SITE NOTICE

Consent No: **20172013** Date Printed: **7 February 2020**
Applicant: **Spaghetti Junction Limited**
Site Address: **80 Byron Street Sydenham**
Legal Description: **Lot 1 DP 449853**
Work Type: **Addition to Factory - New Offices, Meeting and Store Room**
Email To: **todd@morelconstruction.co.nz**

Inspection Type: **210 - Commercial - Final**
Inspection Outcome: **Fail**
Inspected By: **Brian Abrahams**
Inspection Date: **7 February 2020**

Taken at 8:36 AM on Friday 7/02/2020

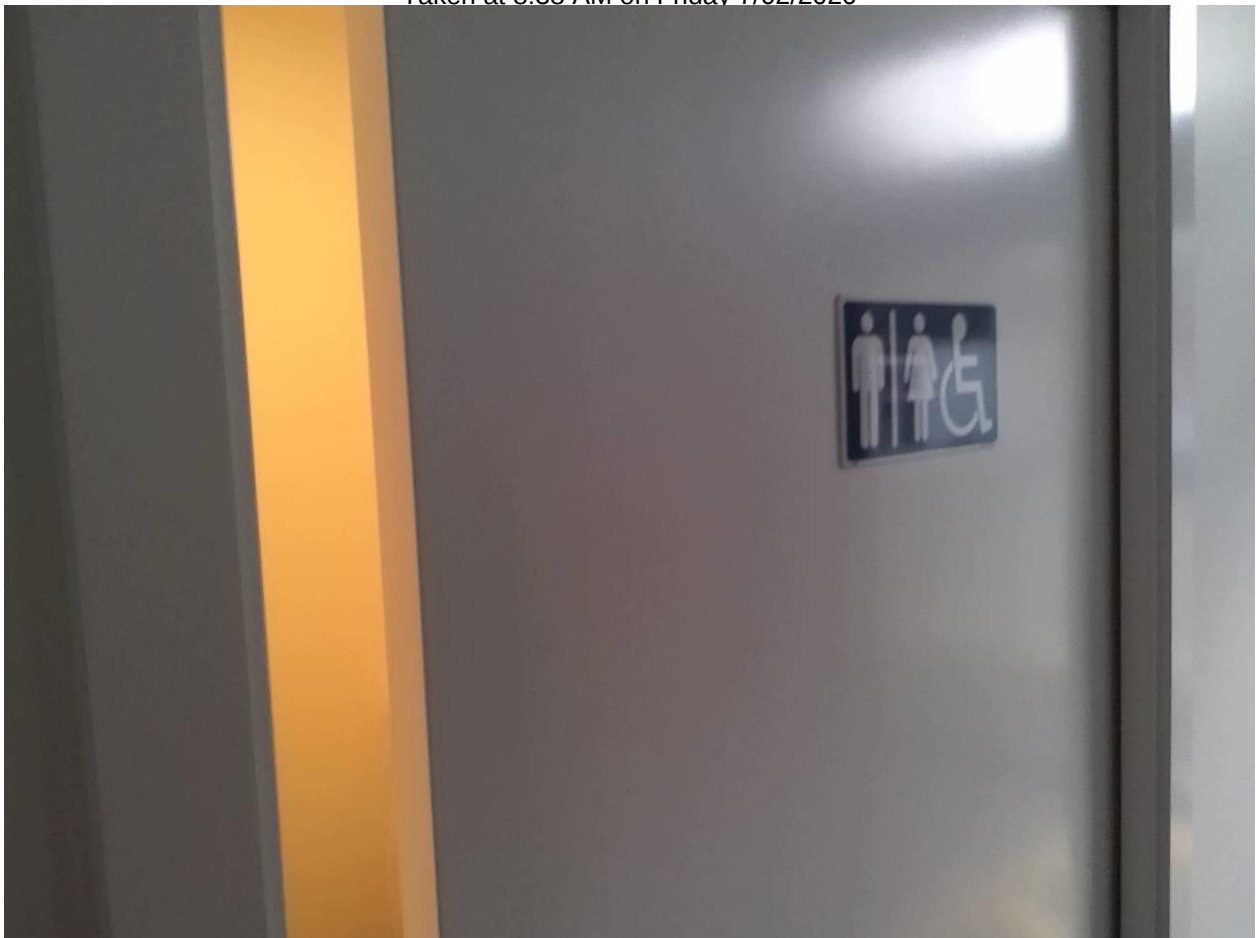
Accessible wc door---handle moves up & down for lock/unlock

Backflow preventor

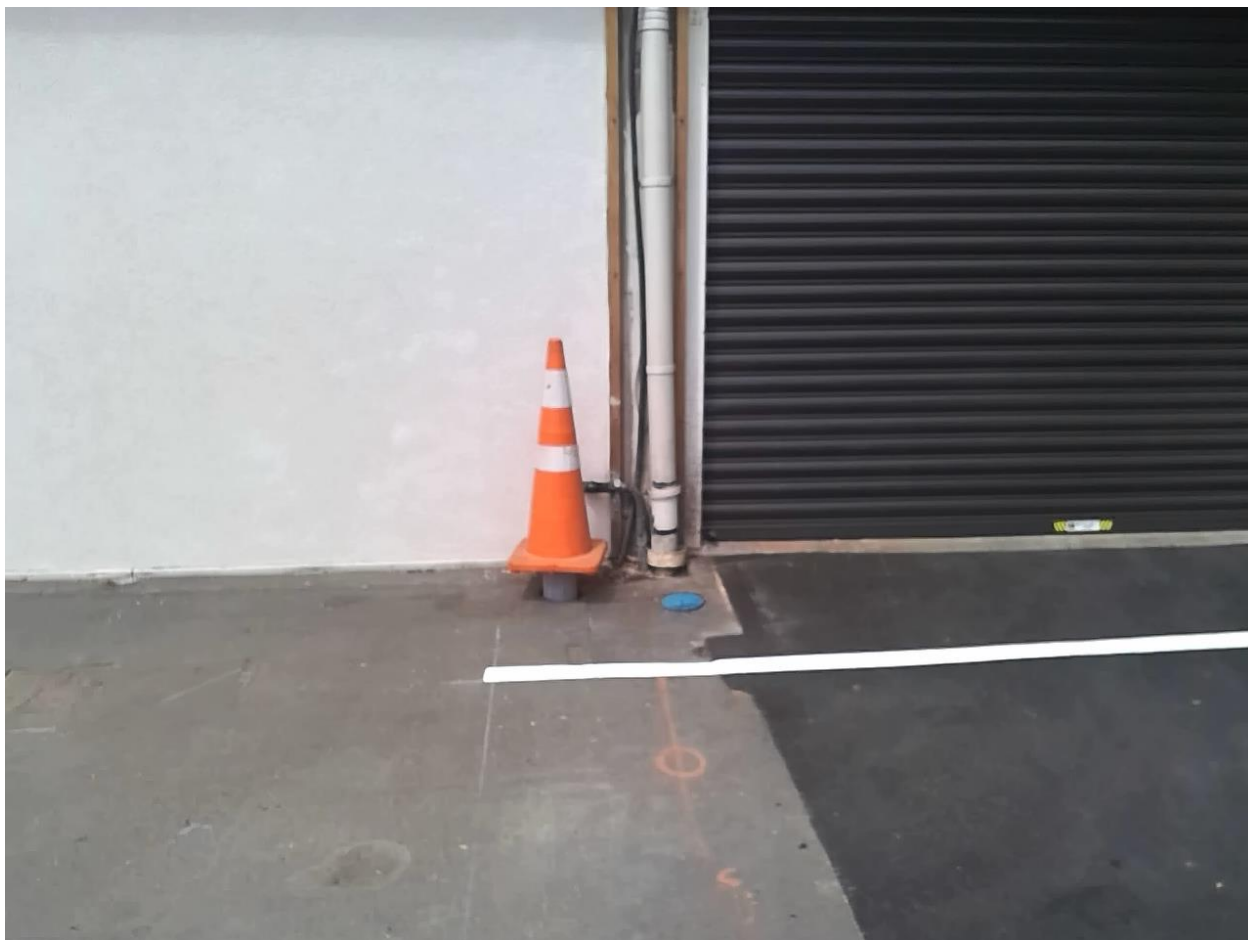
Proposed position of new backflow preventing device not installed yet

- 1. Kerb & channel to be completed.**
- 2. ISA signage required.**
- 3. UV protection required @ lagging @ gas mixer.**
- 4. Soffit to be sealed/painted.**
- 5. Owner's written approval required for change in building paper as requested in 253 inspection.**
- 6. Backflow prevention device required..see attached photos.**
